Serial No. **09/898,040**

Docket No. **K-0280**

Amendment dated **April 12, 2006**

Reply to Office Action of **October 12, 2005**

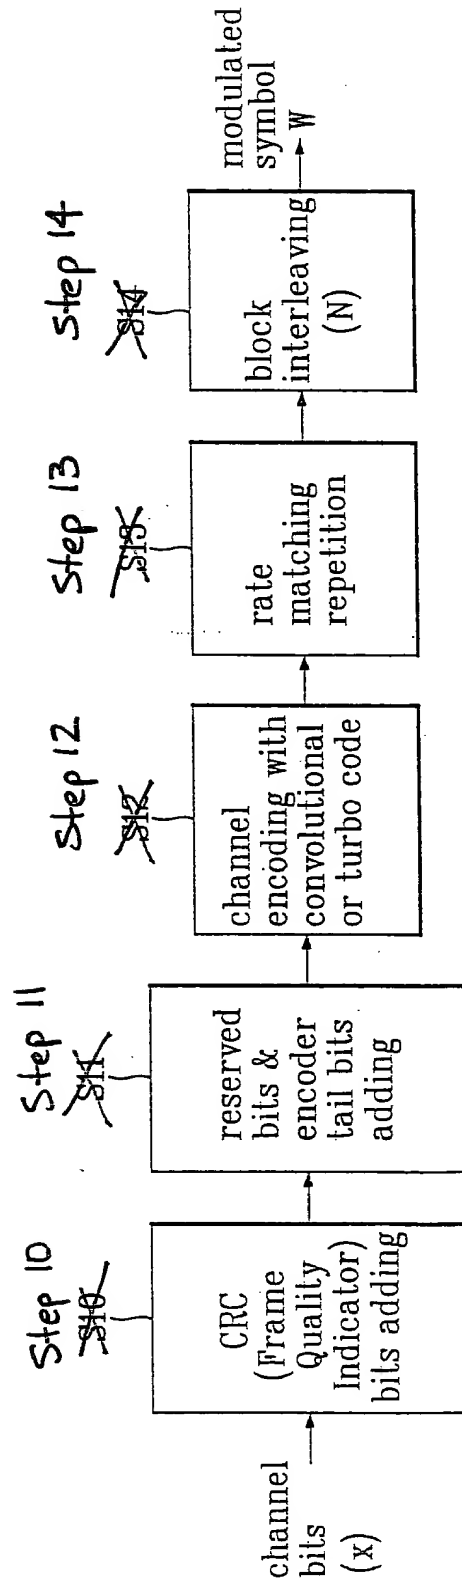
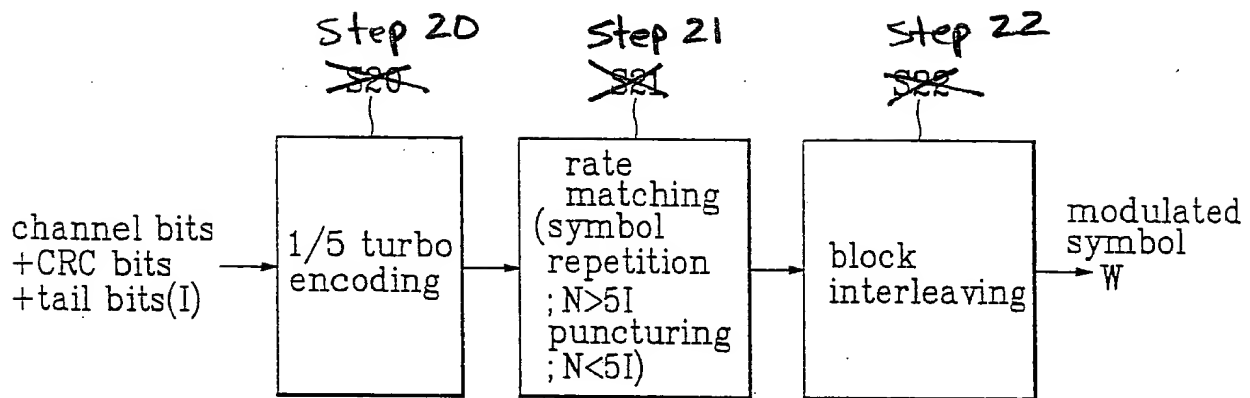
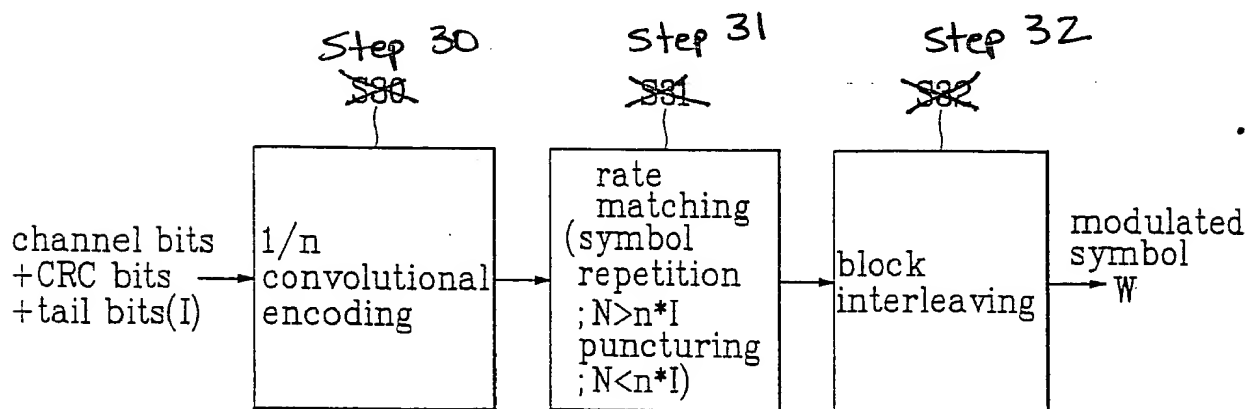
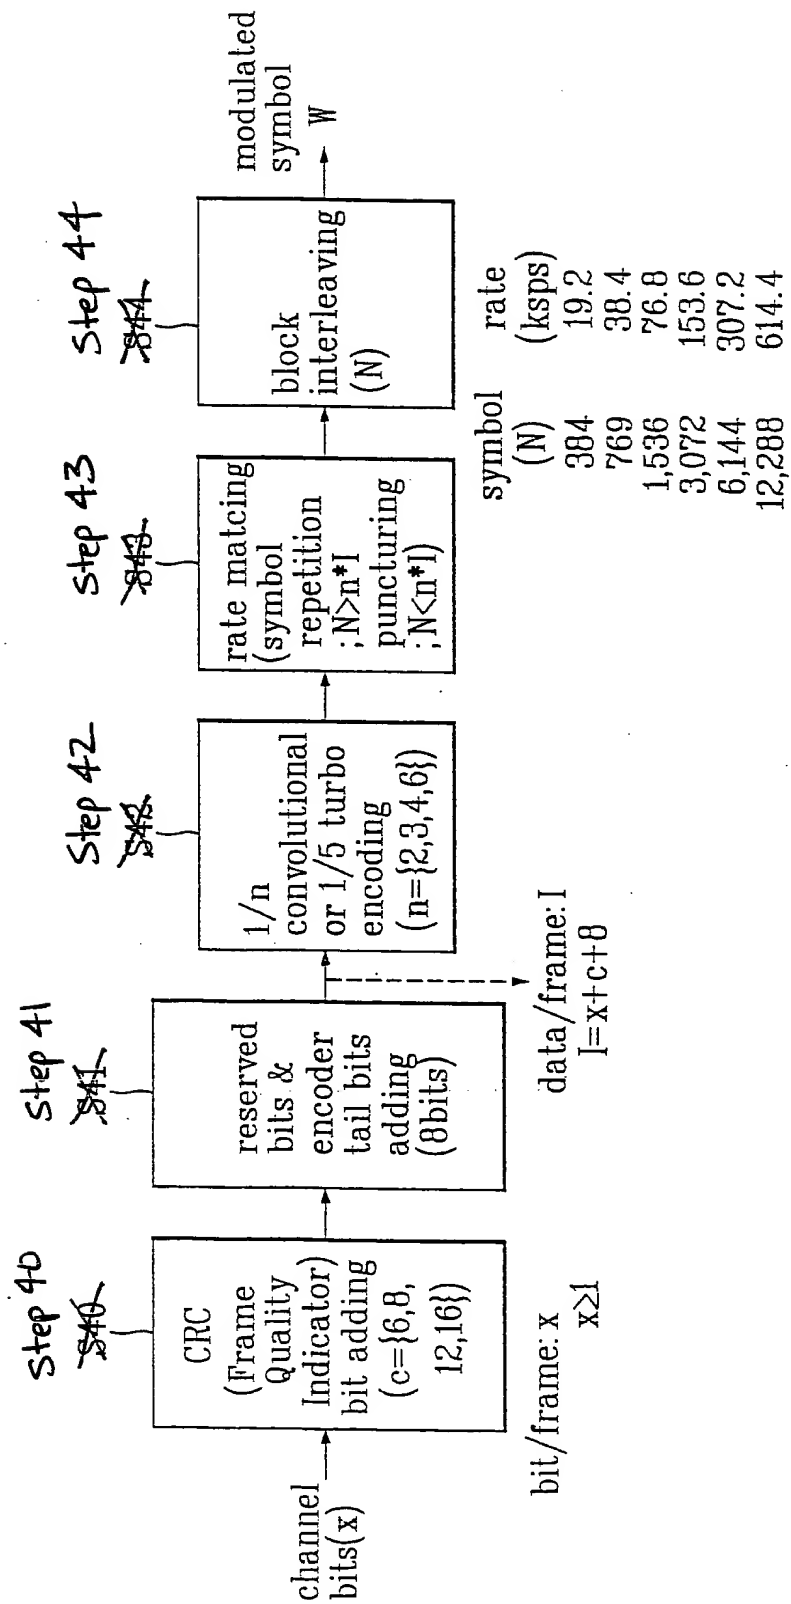
The drawings stand objected to based on minor informalities. Although the acronym “S” is standard labeling for steps, the drawings have been amended per Examiner’s request. Hence, withdrawal of this objection is respectfully requested.

The attached drawings include changes to Figures 1-5. These sheets, which include Figures 1-5, replace the original sheets including Figures 1-5.
